RESPONSE TO REQUEST FOR ADDITIONAL INFORMATION

APR1400 Design Certification

Docket No. 52-046

RAI No.: 323-8281
SRP Section: 7.3
Application Section: 07.03 – Engineered Safety Features Systems
Date of RAI Issue: 11/30/2015

Figure 7.3-1 Simplified Functional Diagram of the ESF-CCS

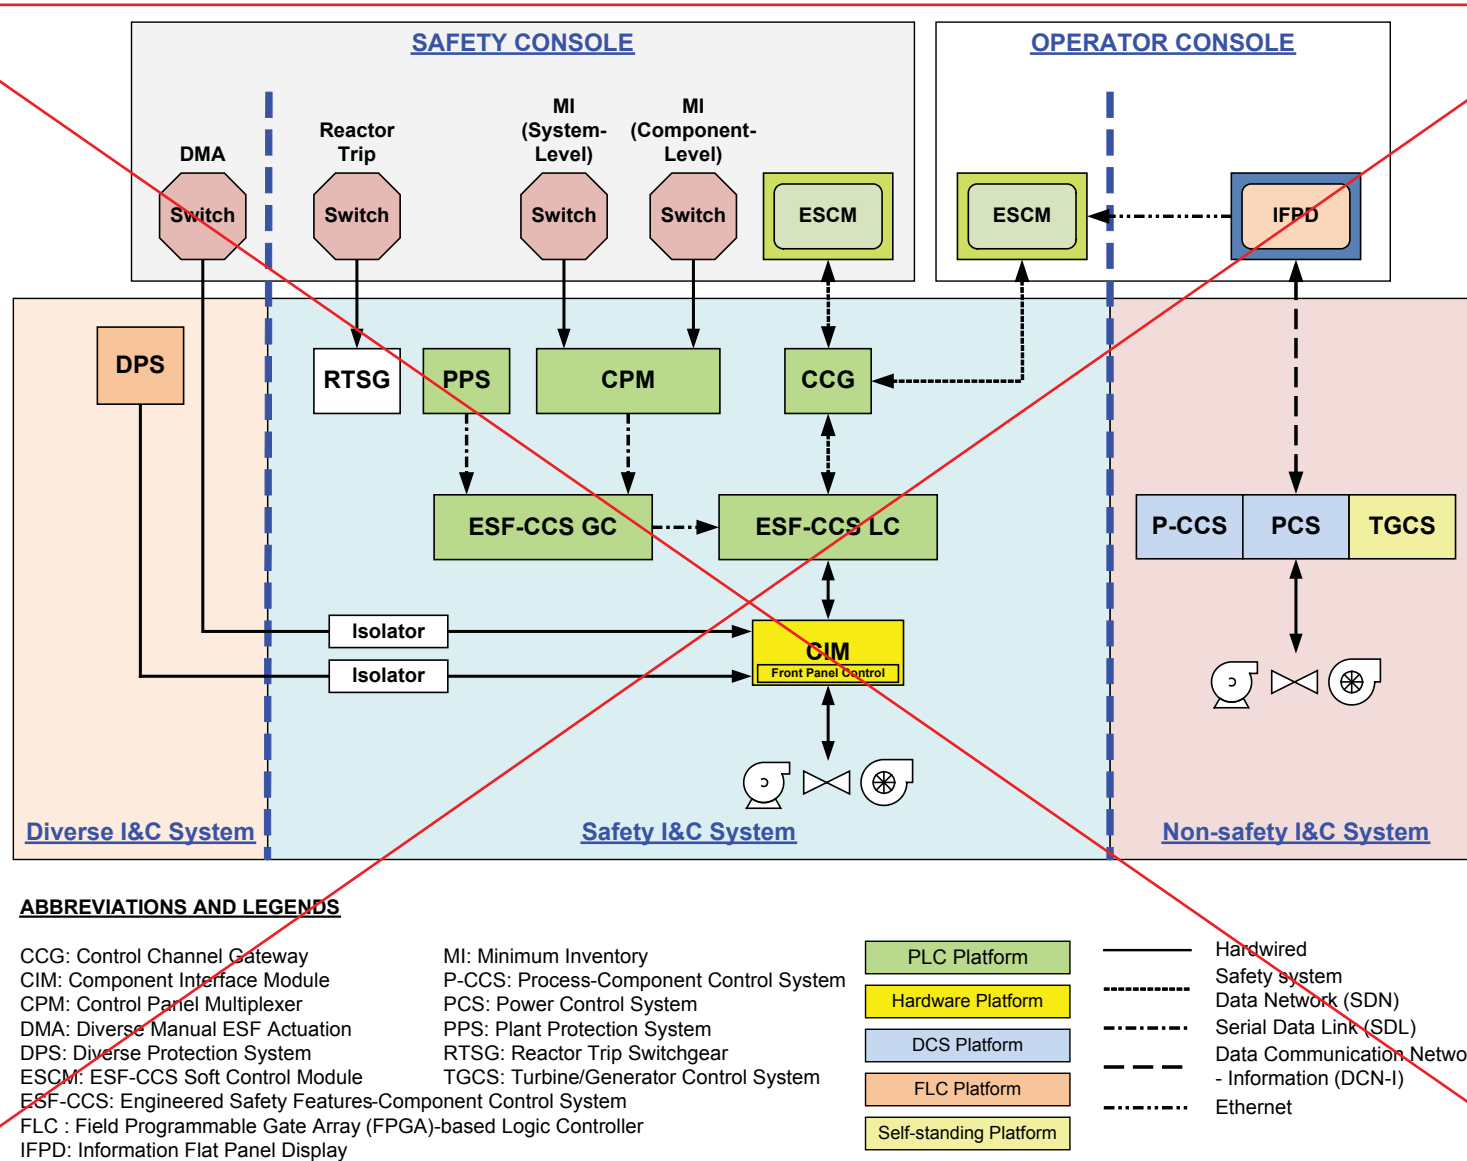
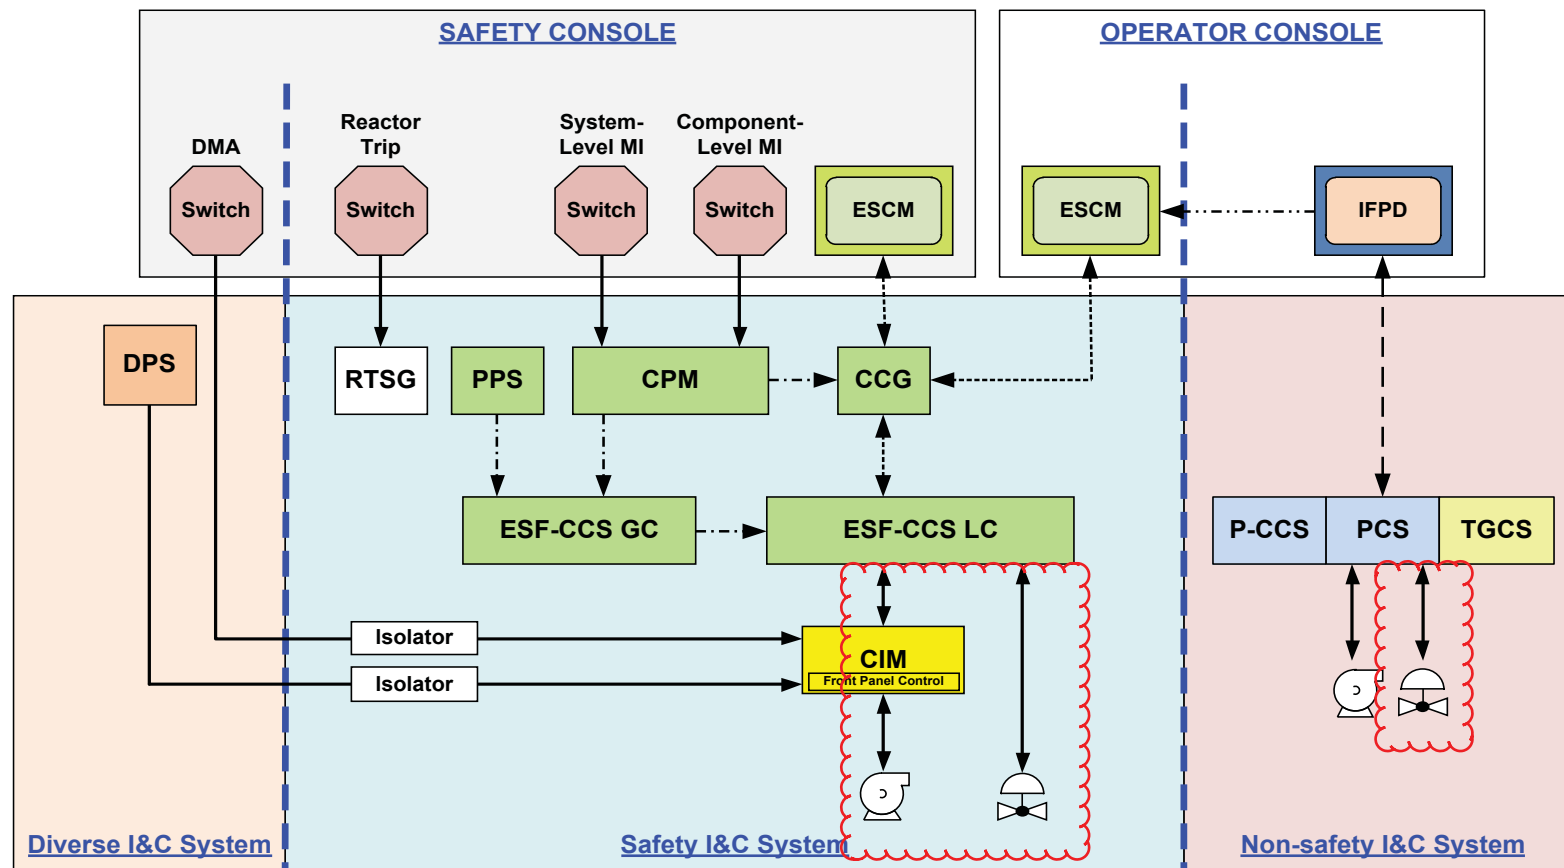
Figure 7.3-1, “Simplified Functional Diagram of the ESF-CCS,” in APR1400 FSAR Tier 2, Section 7.3, and Figure 4-13, “ESF-CCS Functional Configuration,” in Technical Report APR1400-Z-J-NR-14001-P, Rev. 0, “Safety I&C System,” illustrate the CIM being used to actuate all ESF components without differentiation between on-off and modulating ESF components. Figure 5.3-1, “Priority Logic Configuration in the CIM for the APR1400,” of Technical Report APR1400-E-J-NR-14001-P, Rev. 0, “Component Interface Module,” shows discrete inputs only to the priority logic section of the CIM for the ESF components. In the APR1400 application there is lack of design information on how safety-related control functions are implemented in the ESF-CCS system for ESF modulating components. Provide a clear description on how modulating control functions for certain ESF components are accomplished and update the technical report and FSAR figures and descriptions accordingly.

The engineered safety features-component control system (ESF-CCS) provides modulating control functions of safety-related components. For modulating control in ESF-CCS, the sensors and actuators for modulating control are directly interfaced to the analog input (AI) module and the analog output (AO) module in the ESF-CCS loop controller (LC). Any non-discrete

components which require modulation are controlled via the analog output (AO) module in the ESF-CCS LC without the CIM. The ESF-CCS soft control module (ESCM) provides the means for manual modulating control of safety-related components.

The ESCM sends component control signals to the control channel gateway (CCG) through the safety system data network (SDN). The CCG sends component control signals to the ESF-CCS LC through the SDN.

The ESCM sends manual operator demands such as auto/manual mode change, setpoint value in auto mode, and output value in manual mode, to the ESF-CCS LC through the CCG, and the ESF-CCS LC sends the actuator demand output. The component interface module (CIM) is bypassed.

Section 7.3.1 and Figure 7.3-1 of APR1400 DCD Tier 2 will be revised to present how safety-related control functions are implemented in the ESF-CCS system for ESF modulating components, as indicated in the attachment associated with this response.

Figure 7.3-16 CLD for a Throttling Motor-Operated Valve

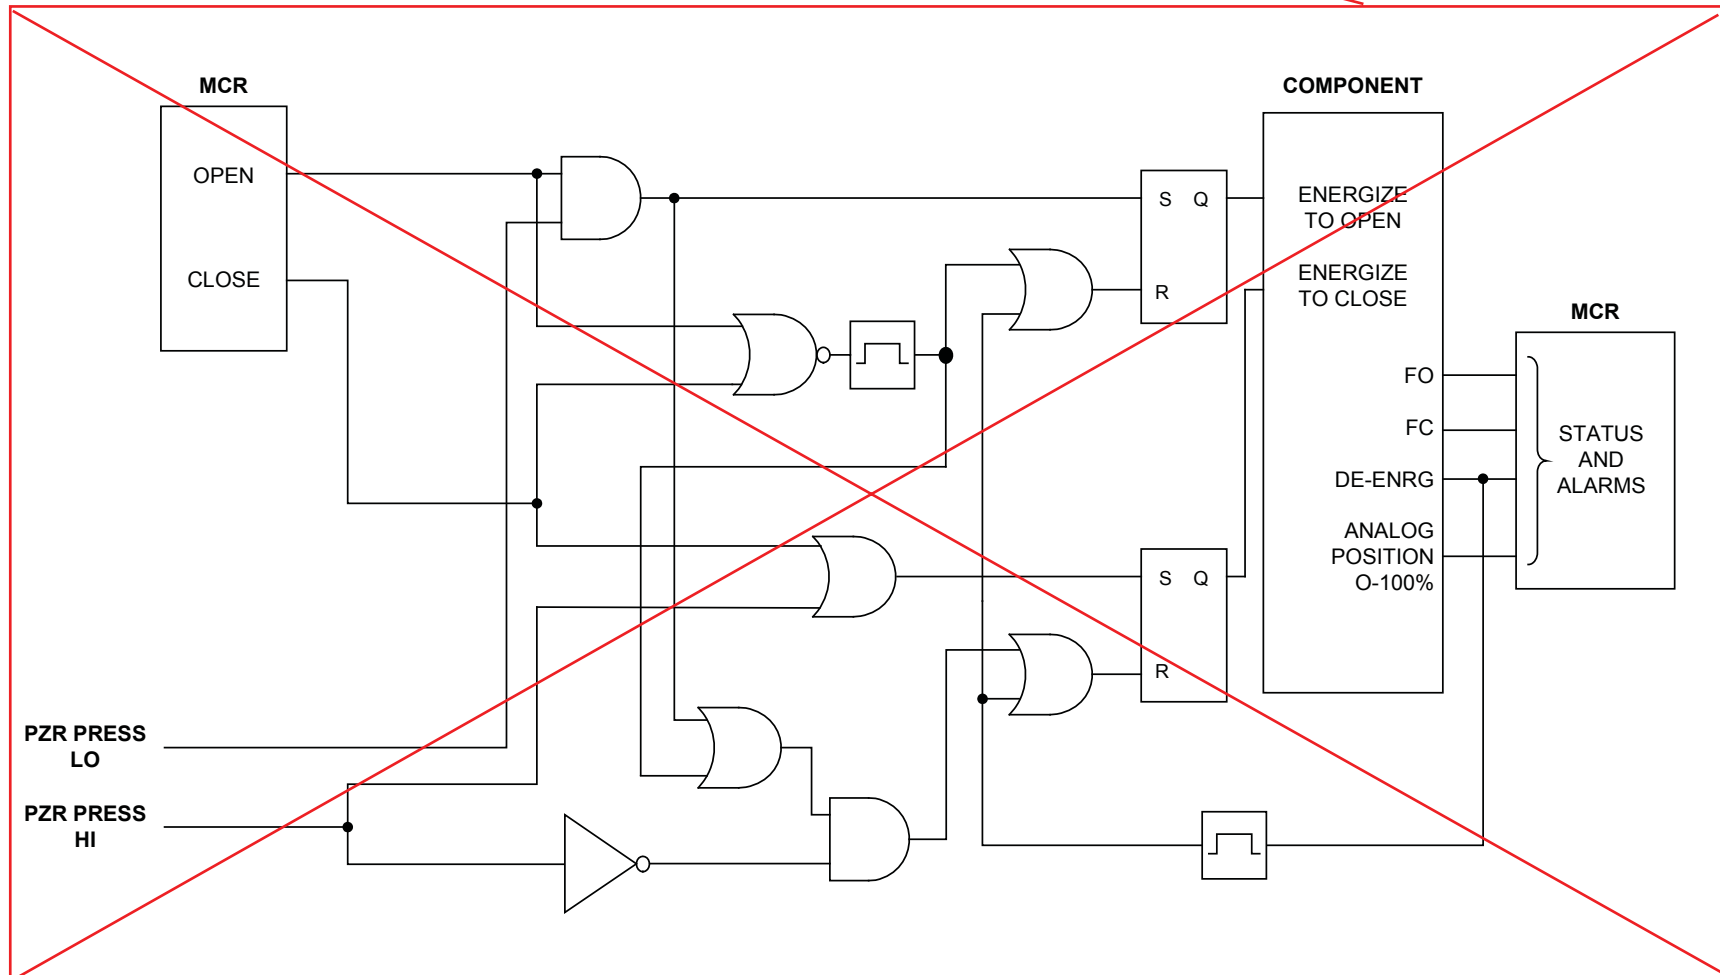
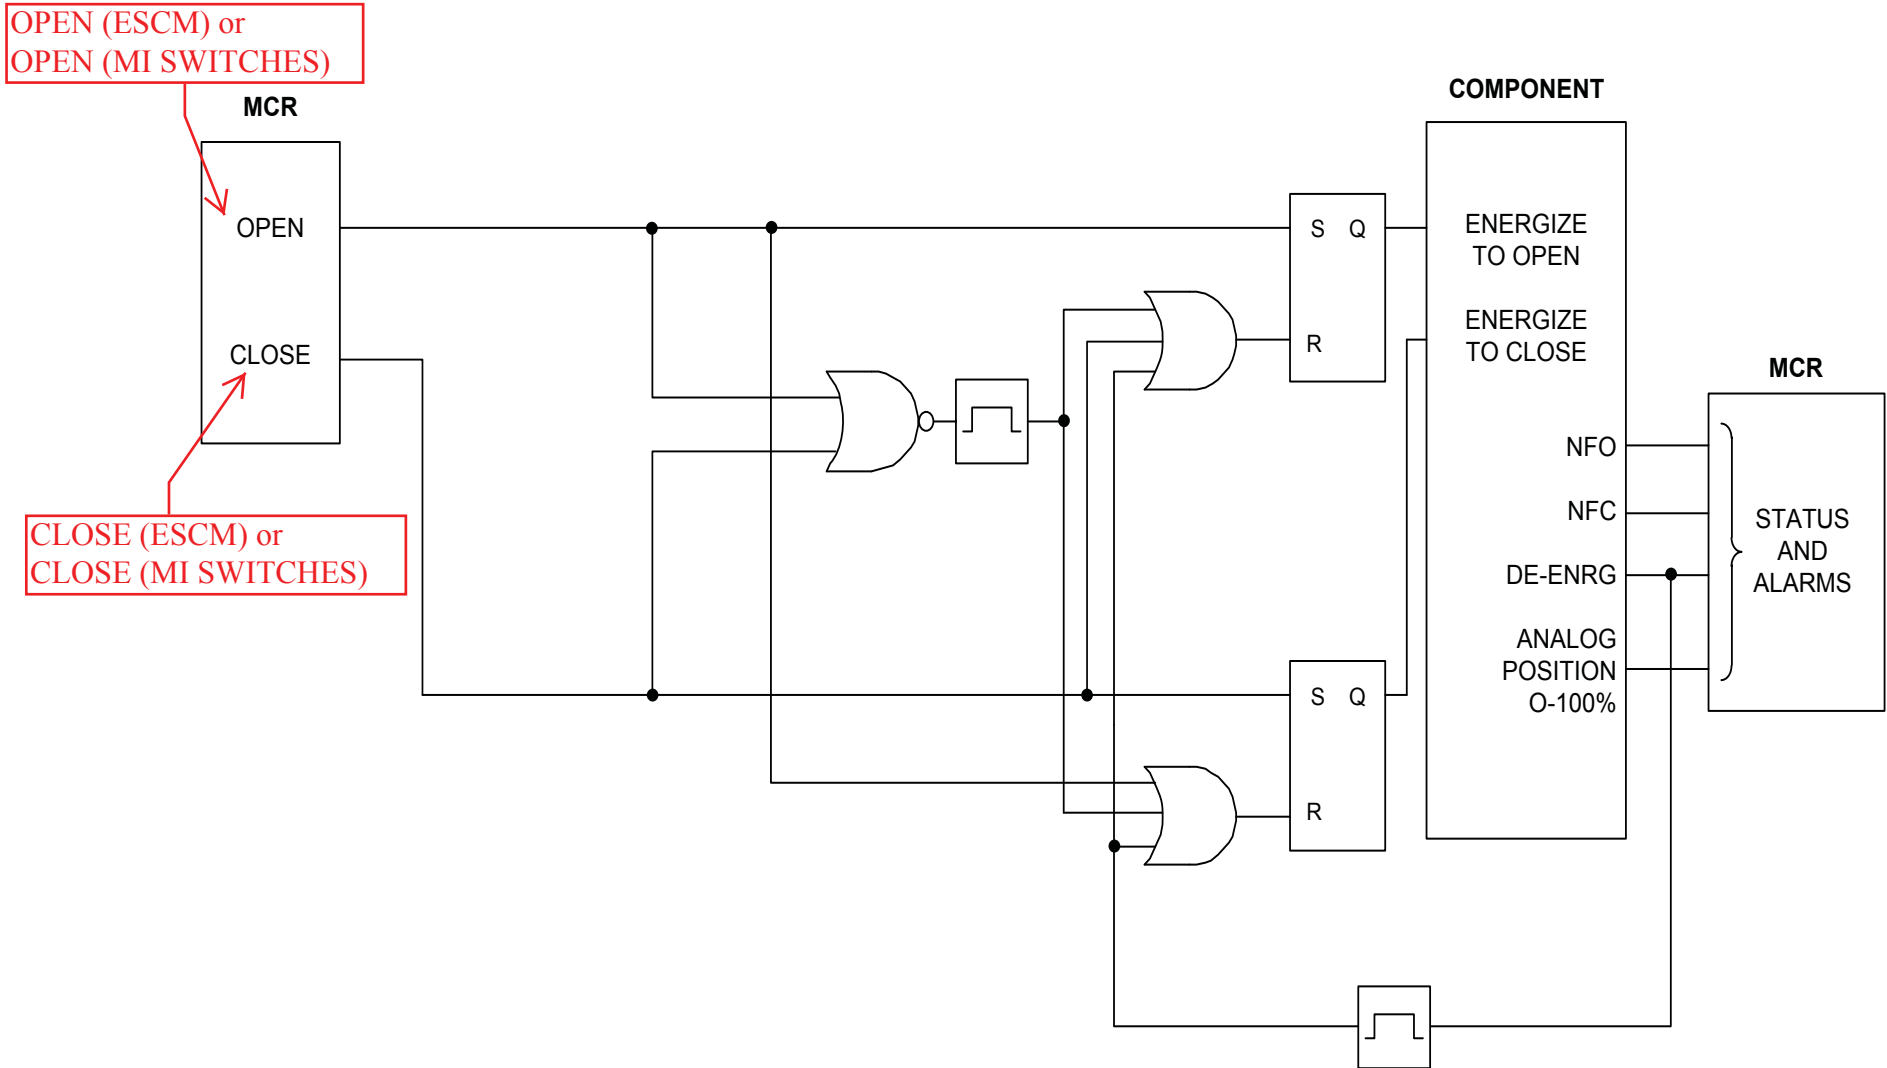
Provide necessary design information to clarify the inputs of component control logic for the ESF systems in Figure 4-15, "Simplified Component Control Logic," in Technical Report APR1400-Z-J-NR-14001-P, Rev. 0, "Safety I&C System." Also provide design information on how each specific component control logic given in Section 7.3.1.4, "Component Control Logic," of APR1400 FSAR Tier 2 are used with logic shown in the above Figure 4-15.

Figure 4-15 in Technical Report APR1400-Z-J-NR-14001-P, Rev. 0, "Safety I&C System", shows the simplified component control logic for ESF components. However, there is lack of definition or descriptive information in the APR1400 application for some logic inputs showing in the above diagram, such as process control (auto start), auxiliary stop, etc. Provide definition and functional description of logic inputs shown in Figure 4-15 which are not included in the application. Section 7.3.1.4 and its related component logic diagrams (CLD) in Figures 7.3-12 to 7.3-20 of APR1400 FSAR Tier 2 show the actuation logic for each type of ESF components. But, there is lack of design information on what relationship exists between those CLD figures and Figure 4-15 in the above Technical Report. Describe how each specific type of component logic diagram given in Section 7.3.1.4 of APR1400 FSAR Tier 2 is to be applied together with Figure 4.15 in the Safety I&C Technical Report.

The relationships between Figures 7.3-12 to 7.3-18, and 7.3-20 of DCD Tier 2 and Figure 4-15 of the Safety I&C System TeR, APR1400-Z-J-NR-14001-NP, Rev.0 will be provided, as indicated in the attachment associated with this response. DCD Tier 2, Figure 7.3-19 has no relationship to Figure 4-15 of the Safety I&C System TeR.

Figure 7.3-16 of DCD Tier 2 will be revised, as indicated in the attachment associated with this response.
